Planned Change Request

**Waste Isolation Pilot Plant
Repository Reconfiguration**

**DOE/CBFO 11-3478
Revision 0**

**United States Department of Energy
Waste Isolation Pilot Plant**

Figure 2. Plan view of the revised repository layout

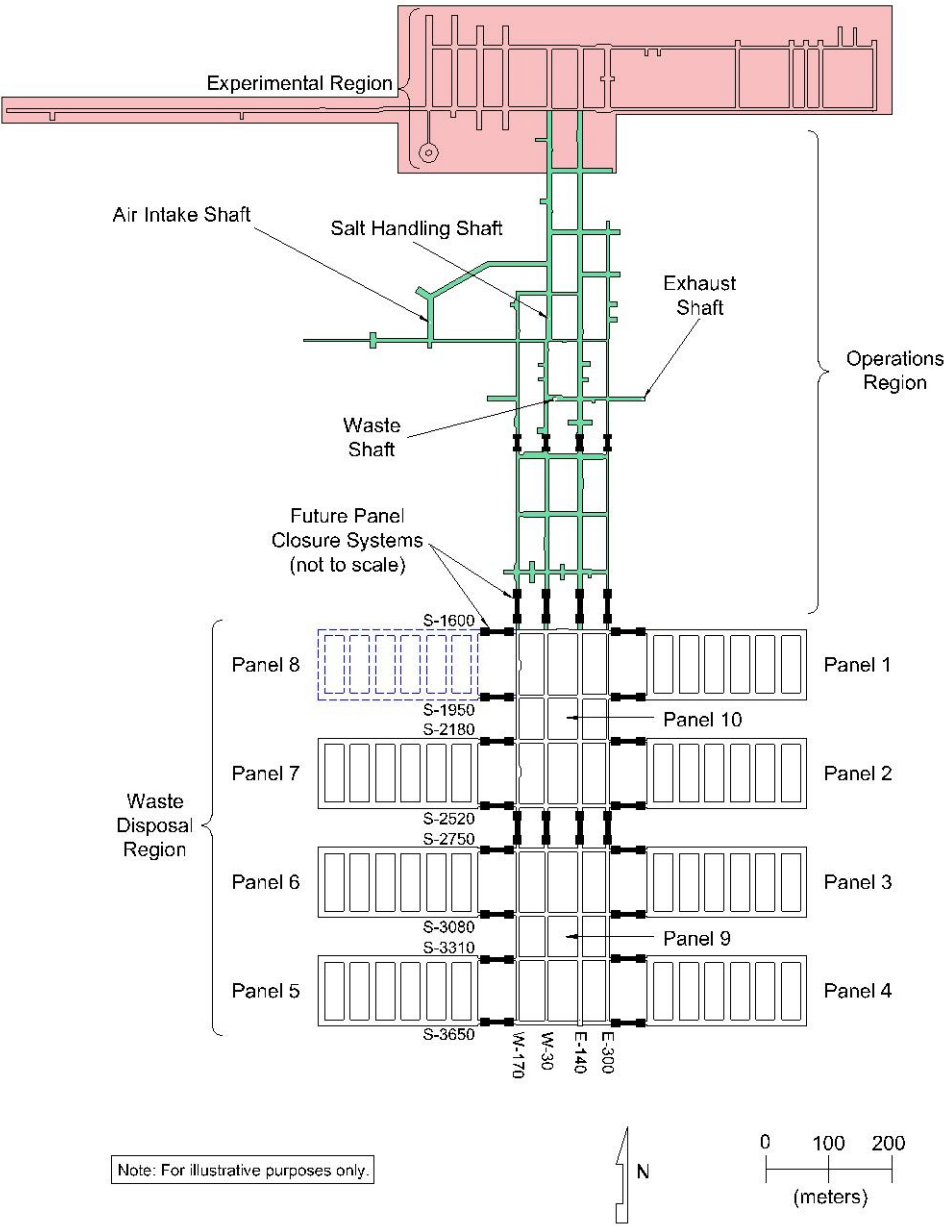
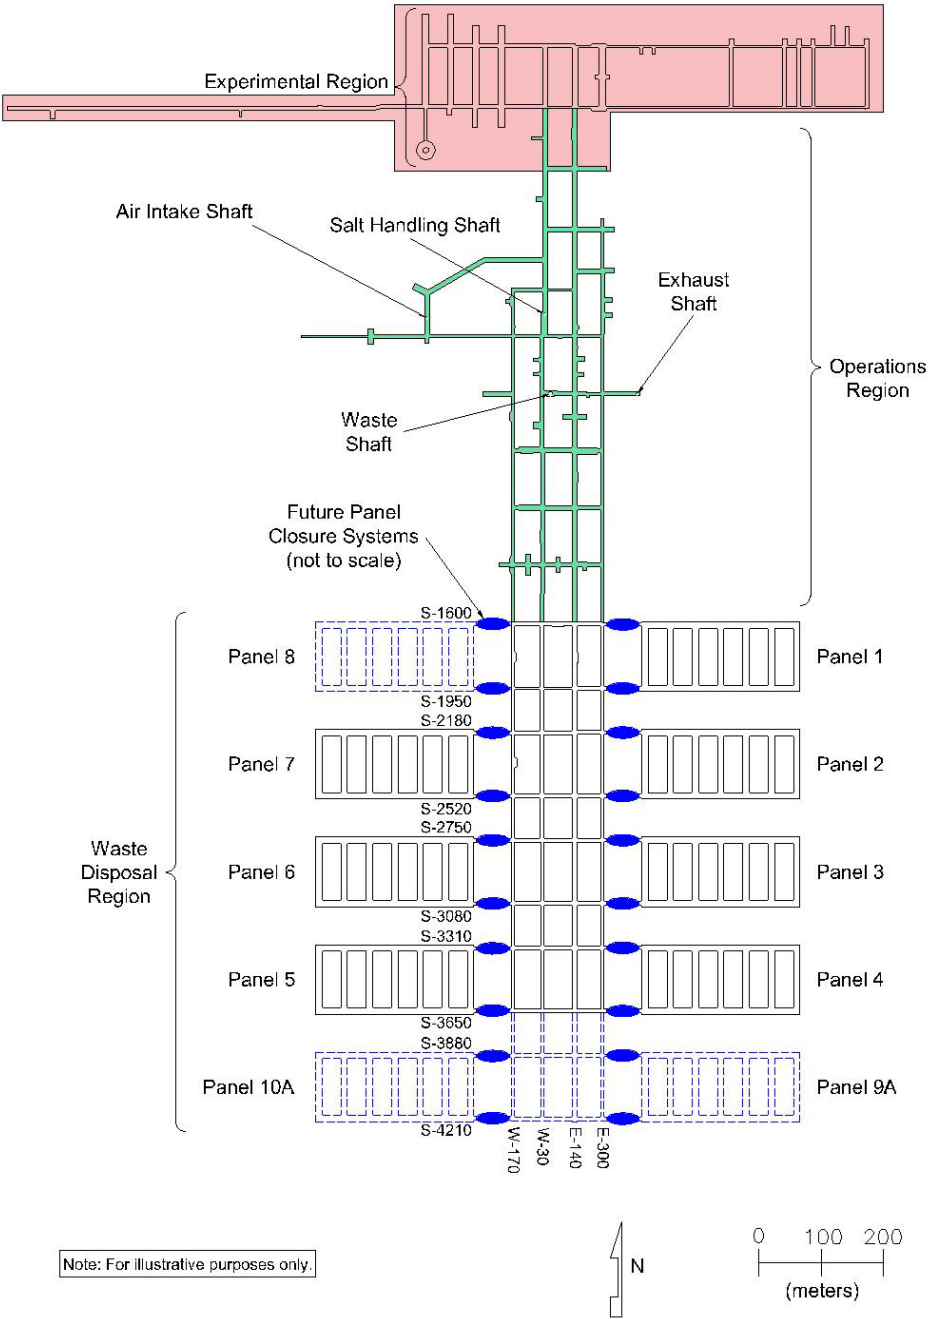
The U.S. Department of Energy (DOE) is proposing a change to the configuration of the repository at the Waste Isolation Pilot Plant (WIPP). The proposed configuration will relocate Panels 9 and 10 from the main north-south access drifts to south of the existing Panels 4 and 5. The DOE requests this change based on the following observations:

After years of mining and waste disposal activities, geotechnical issues in the main access drifts and cross drifts have been identified. Portions of these access drifts which were initially mined six to 30 years ago. The ongoing ground movements are controlled and safe access is ensured through continuing maintenance. However, given the age of the main access drifts and the need to widen these drifts for emplacement of RH TRU waste, any additional excavation to enlarge these entries for waste disposal will cause an increase in ground movements that must be controlled. As a result, the DOE has evaluated the relocation of the waste destined for disposal in Panels 9 and 10 to an alternate location in the underground facility south of the existing Panels 4 and 5. Figure 2 shows the proposed reconfiguration, with 10 panels for waste emplacement and a central region without waste.

As the repository ages, the condition of the host rock locally around the excavations degrades. Ground support systems need to be installed and additional mining and scaling performed to maintain safe access. If the south access drifts are enlarged for disposal of CH TRU and RH TRU waste, the response to the removal of pillar volume and to the increase in roof span will be an increase in convergence rates by a factor of 3.6 or more, based on *in situ* observations. In another example that demonstrates the response to enlarging an access drift, Figure 4 shows the convergence rates for an access drift that was widened from 16 ft to 20 ft. The measurements were taken in an area located within the footprint for Panel 10, near the intersection of W-30 and S-2067. Figure 4 demonstrates that the vertical convergence rate increases from less than 1 in/yr before widening to approximately 3.5 in/yr after widening. Given these observed geotechnical responses, DOE recommends that the main north-south access drifts should not be enlarged, and that Panels 9 and 10 should be relocated to south of Panels 4 and 5 (i.e., south of S-3650), as shown in Figure 2.

The DOE is proposing a change to the configuration of the repository at the WIPP. The current configuration will use the main north-south access drifts, suitably enlarged, as Panels 9 and 10 for waste disposal. However, the main north-south access drifts have been open for about 25 years, and a geotechnical assessment of these openings indicates that relocating Panels 9 and 10 to south of the existing Panels 4 and 5 will enhance worker safety and reduce maintenance requirements. Therefore, it is DOE's intention to replace Panels 9 and 10 with two new waste disposal panels, designated as Panels 9A and 10A, to the south of Panels 4 and 5.

Figure 3 Convergence rate increase at W-30, S-2275 after drift was widened

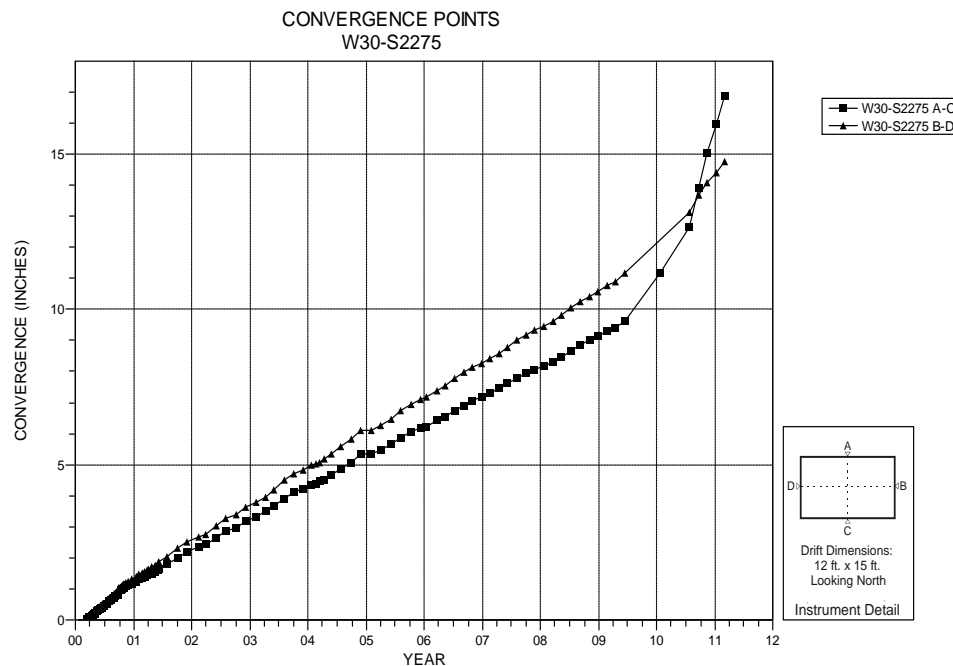
The W-30 drift was initially mined to 13 ft high by 16 ft wide between February 1986 and December 2000. Additional mining completed in July 2010 enlarged this section to 15 ft high by 20 ft wide. After the final excavation, the convergence rates in W-30 Panel 9

range from 1.25 to 5 in/yr as indicated in Table 1. Table 1 show the average convergence rates (inches per year) from measurements taken from mid 2009 to mid 2010. The E-140 drift was initially mined to 8 ft high and 25 ft wide in 1983.

Figure 4. Comparison of vertical and horizontal convergence rates before and after widening the access drift near W-30 and S-2067 (within footprint of Panel 10)

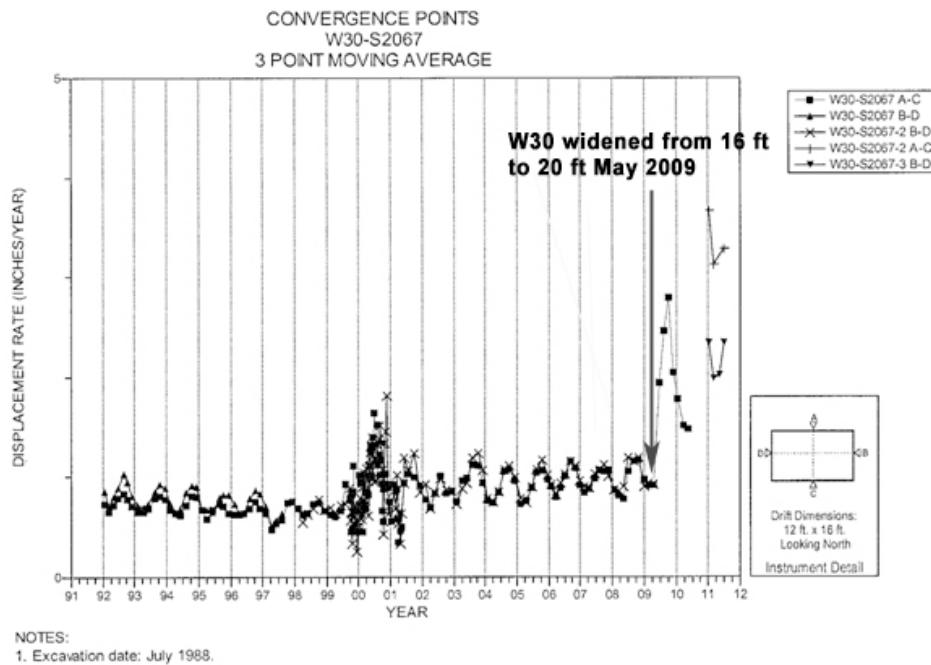
- Widening the access drifts has shown an increase in convergence rates as high as 367%, based on observations from a drift that was widened within the footprint for Panel 10.

Figure 5 Overall mean CCDFs for total normalized releases for the PC3R PA and for PABC-2009

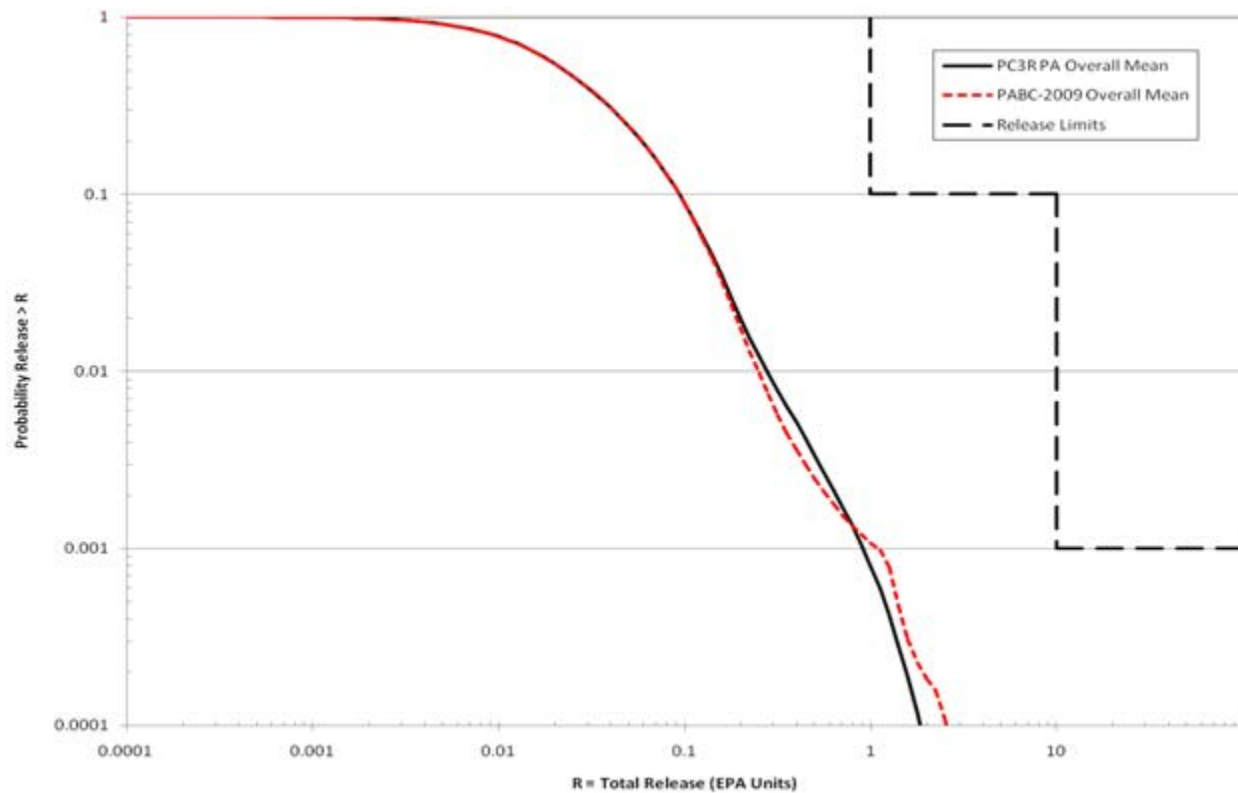
revised panel closure design with an open central area will produce small differences from the PABC-2009, as shown in Figure 5. The primary cause of these small differences is the time required for the run-of-mine salt to reconsolidate combined with the open central area, resulting in reduced repository pressure in the waste emplacement panels (Camphouse et al. 2011).

Figure 5 presents the predicted total mean normalized releases for the PC3R PA and the PABC-2009. The results in Figure 5 demonstrate that the differences in predicted total mean normalized releases for the PC3R PA and PABC-2009 are relatively minor throughout the probability range of 0.001 to 1 and essentially equal for probabilities between 0.01 and 1. The numerical values in Table 3 (Camphouse et al. 2011, Table 11) also demonstrate that the statistics for the distribution of complementary cumulative distribution functions (CCDFs) about the mean are similar for the PC3R PA and for the PABC-2009. It follows that the mean values and the distributions of total normalized releases for the combined changes from repository reconfiguration and panel closure redesign are very similar to the corresponding parameters for the PABC-2009. In addition, the mean total normalized release from the PC3R PA is 0.89 at a probability of 0.001 (see Table 3), and therefore the potential releases for the PC3R are less than those calculated for the PABC-2009.
